**PCN# 20200520000.2  
Packing material change for Select Device(s)  
Change Notification / Sample Request**

**Date:** June 08, 2020  
**To:** Newark/Farnell PCN

<b>PCN Number:</b>	20200520000.2		<b>PCN Date:</b>	June 8, 2020	
<b>Title:</b>	Packing material change for Select Device(s)				
<b>Customer Contact:</b>	<a href="#">PCN Manager</a>	<b>Dept:</b>	Quality Services		
<b>Proposed 1<sup>st</sup> Ship Date:</b>	Dec. 8, 2020		<b>Estimated Sample Availability:</b>	Date provided at sample request	
<b>Change Type:</b>					
<input type="checkbox"/>	Assembly Site	<input type="checkbox"/>	Design	<input type="checkbox"/>	Wafer Bump Site
<input type="checkbox"/>	Assembly Process	<input type="checkbox"/>	Data Sheet	<input type="checkbox"/>	Wafer Bump Material
<input type="checkbox"/>	Assembly Materials	<input type="checkbox"/>	Part number change	<input type="checkbox"/>	Wafer Bump Process
<input type="checkbox"/>	Mechanical Specification	<input type="checkbox"/>	Test Site	<input type="checkbox"/>	Wafer Fab Site
<input checked="" type="checkbox"/>	Packing/Shipping/Labeling	<input type="checkbox"/>	Test Process	<input type="checkbox"/>	Wafer Fab Materials

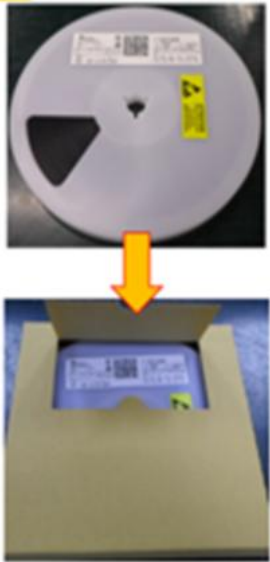
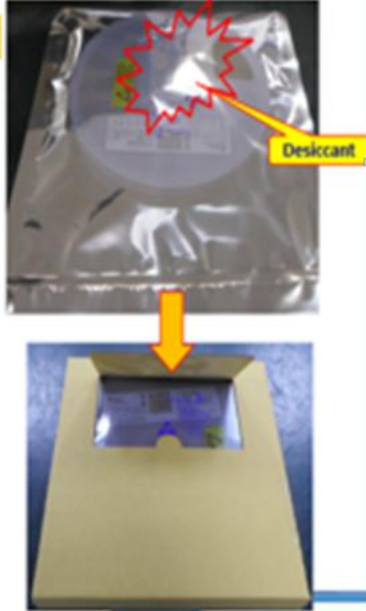
<input type="checkbox"/>	Wafer Fab Process
<b>PCN Details</b>					
<b>Description of Change:</b>					
This change notification is to announce the addition of using ESD sealed bag for the shipping reel before placing inside the Pizza Box for select devices listed in the "Product Affected" Section.					
	<b>From</b>		<b>To</b>		
Packing Description	Reel into Pizza Box		Reel in ESD Sealed Bag inside the Pizza Box		
Visual comparison					
<b>Reason for Change:</b>					
Prevent lead discoloration / oxidation leading to solderability Test failure					
<b>Anticipated impact on Form, Fit, Function, Quality or Reliability (positive / negative):</b>					
None					
<b>Anticipated impact on Material Declaration</b>					
<input checked="" type="checkbox"/>	No Impact to the Material Declaration	<input type="checkbox"/>	Material Declarations or Product Content reports are driven from production data and will be available following the production release. Upon production release the revised reports can be obtained at the site link below <a href="http://www.ti.com/quality/docs/materialcontentsearch.tsp">http://www.ti.com/quality/docs/materialcontentsearch.tsp</a>
